Detroit
Edison

November 16, 1989
NRC-89-0215

Subject: Proposed Technical Specification Change
(License Amendment) - Control Room Emergency
Filtration System (3/4.7.2)

FIGURE 1

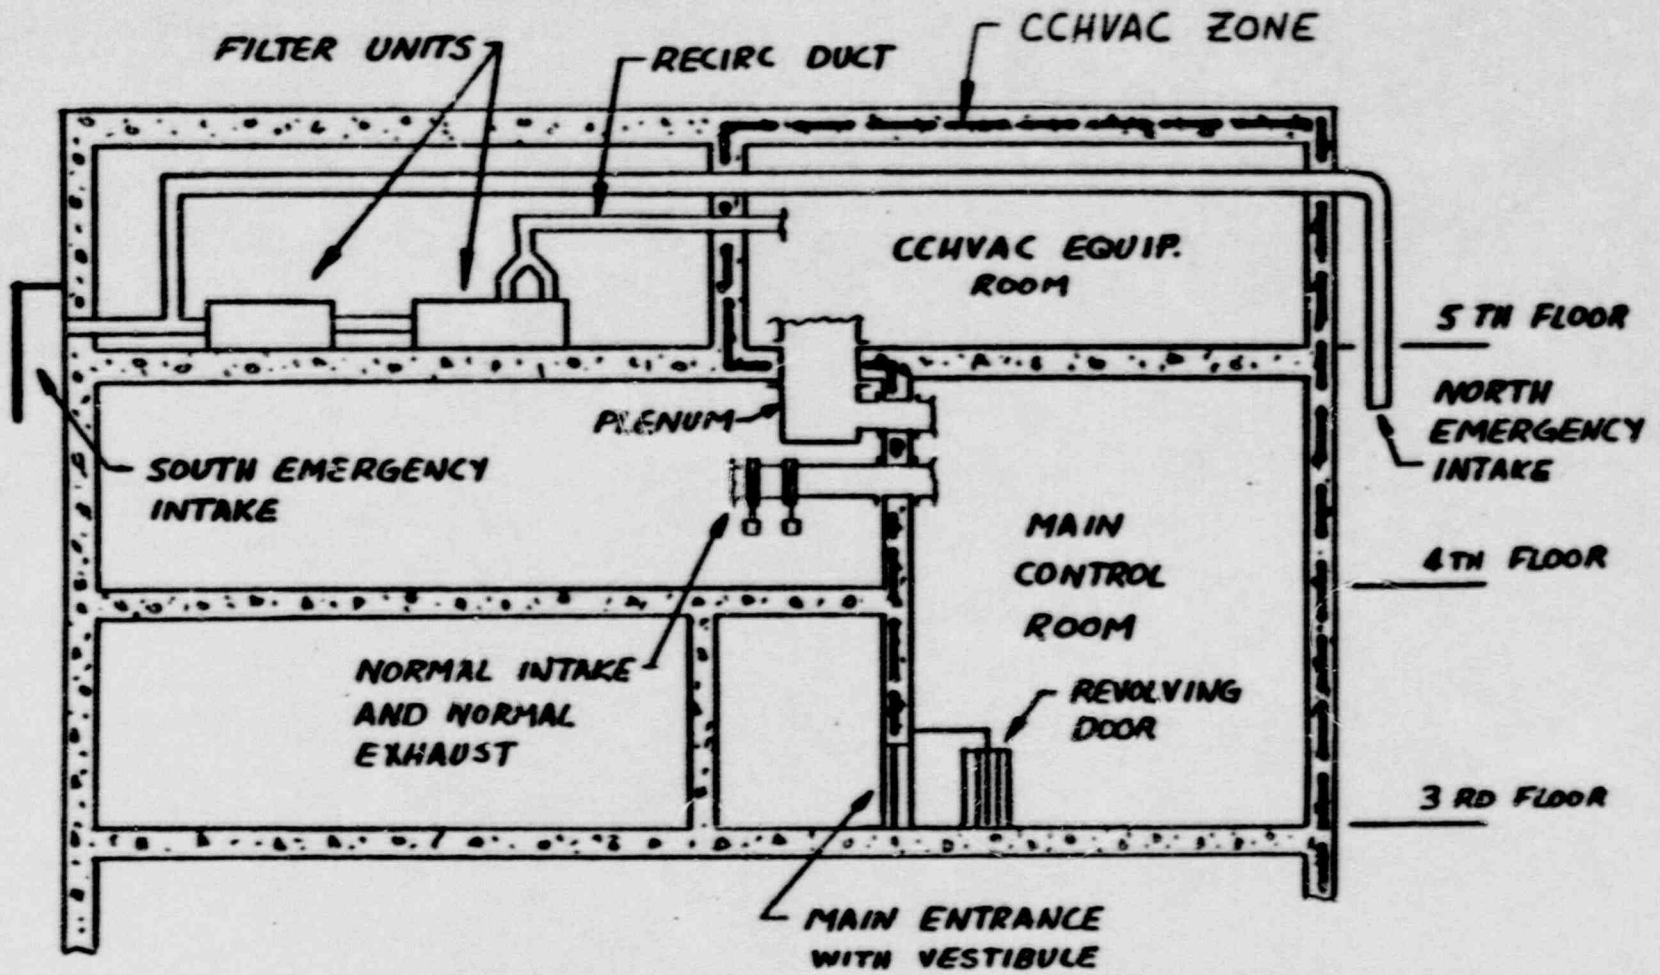
- 1) The ductwork of concern is located in the enclosed Auxiliary Building and is therefore not directly in the radioactive plume created by the accident scenario. (See Figure 1)
- 2) Some portions of the ductwork do not experience negative pressures unless significant filter loading occurs. This condition is not expected to occur.
- 3) There exists a margin of 11.3 rem to the thyroid between the results of the new Control Room dose calculation (18.7 rem thyroid) and the GDC 19 criteria (30 rem thyroid).
